SUBDIVISION WITHDRAWN
SUBDIVIDER: HOKUKANO RANCH, INC.
"Hökūkano Preserve Subdivision"

SUBJECT: VARIANCE-VAR 07-036

**Request: Variance from Chapter 23, Subdivisions,
Design Standards/Improvements**

Tax Map Key: 7-9-001:001,002,003 and 8-1-002:040, (SUB 06-000489)

TYPICAL ROADWAY SECTION 50 FT. R.O.W.
SCALE 1/4" = 1'-0"

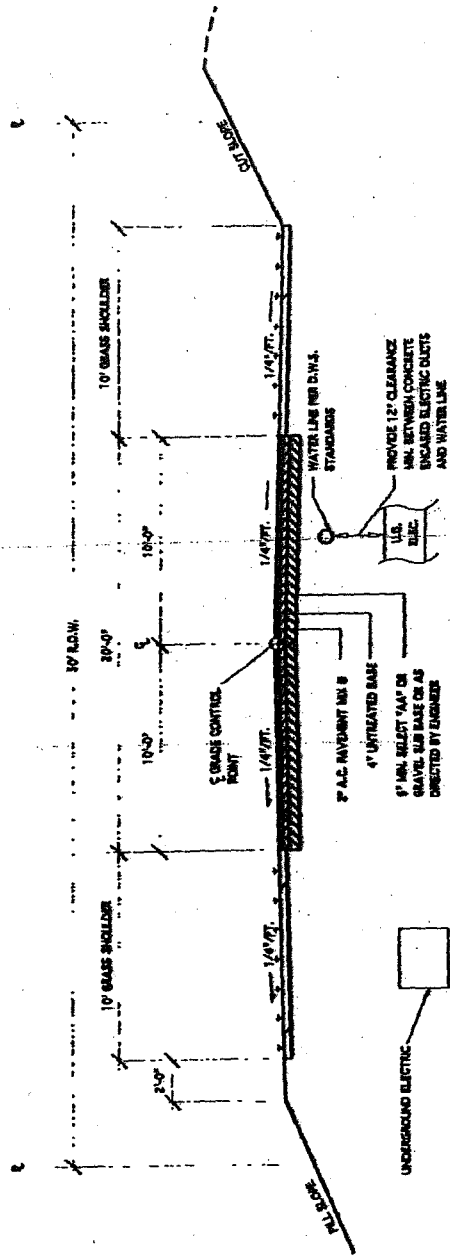
In order to preserve the agricultural, ranch character of the Property, the Applicant proposes to improve Coffee Shack Road, which serves as the primary access to the Property, and Road F, which serves as the secondary access road, with 24 feet of pavement and 10-foot grassed shoulders within an 80 to 100-foot right-of-way (sic) The Applicant also proposes to improve the other internal subdivision roads with a 20-foot pavement and 10-foot grassed shoulders within a 50-foot right-of-way. The variance requested relates to the use of 10-foot shoulder in lieu of full paving of the shoulder. It also relates to grading only the area necessary for the proposed travelway, the shoulder, including any necessary drainage swales but not the entire width of the right-of-way. In addition, the roadway may not be centered within the right-of-way but may meander within the right-of-way to better accommodate the grade of the road. The Applicant believes that full pavement of the shoulder area is not necessary or appropriate given the agricultural, large lot nature of the proposed subdivision. The Applicant has allowed for a 20-foot pavement and sufficient area for the right-of-way has been provided. Please see Exhibit 3 (“Typical Roadway Section Divided Parkway 80’ or 100’ R.O.W.”) and Exhibit 4 (“Typical Roadway Section 50 Ft. R.O.W.”) for detailed diagrams of what the Applicant is proposing.”

- Grassed shoulders should produce less runoff than paved ones because they retain some ability of the ground to absorb water.
- Allowing longer cul-de-sacs reduces the total roadway footage and thus reduces the area of paved, impervious surfaces.
- Allowing the paved area to meander within the right-of-way, and the median, will not increase the flooding potential.
- The steel water tanks and alternative lighting are irrelevant to the flooding potential.

4. ROAD VARIANCE. The subdivider, owners, their assigns, or successors understand that the lots arising out of SUB 06-000489 will use and maintain the privately owned road lots and privately owned non-dedicable roadways including any necessary emergency access and/or utility easements on their own without any expectation of governmental assistance to maintain the non-dedicable roadway improvements within roadway lots identified on the subdivisions preliminary plat map and/or any necessary emergency access and/or utility easement(s) within the proposed subdivision.

7. Along with construction drawings for the roadways using grassed drainage swales and shoulders, or prior to submitting full construction drawings, the applicant shall submit an engineer's report showing that the shoulders and swales will be stable and not erode or wash out during stormwater flow conditions considering the grades and soil conditions. The report shall be reviewed by DPW. The Planning Director, in consultation with DPW, may require paving, stabilization, or alternative shoulder and swale treatment to take care of any erosion problems. The road maintenance association or equivalent shall be responsible for continual maintenance and upkeep of the shoulders and swales. The applicant shall ensure adequate sight distance and roadside clear zones.
